Requests for Clarifications And Responses

Order No. 754 – Data Request

The Study of Single Point of Failure

Revised: December 20, 2012

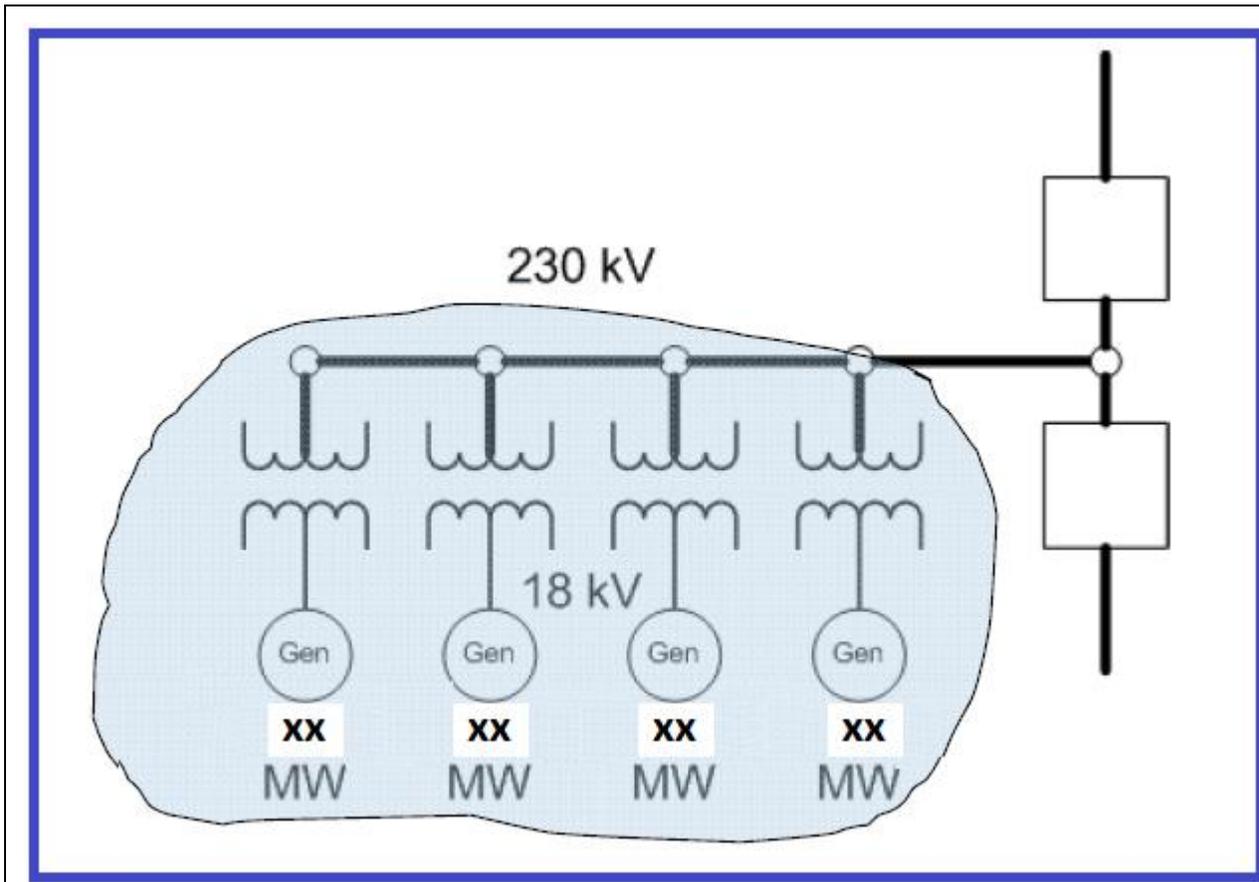
Step 1 Q1. In the example below, please provide guidance in regards to Table A of the Request for Data or Information. Would this generator collector bus with four GSU transformers that has one connection to the substation bus be counted as one GSU transformer or as four GSU transformers?

Step 1 A1. For the purpose of applying Table A it is necessary to determine the number of circuits connected to a bus. In this figure, the generator collector bus with four GSU transformers connected to the 230 kV substation bus via a single connection would be counted as one circuit.
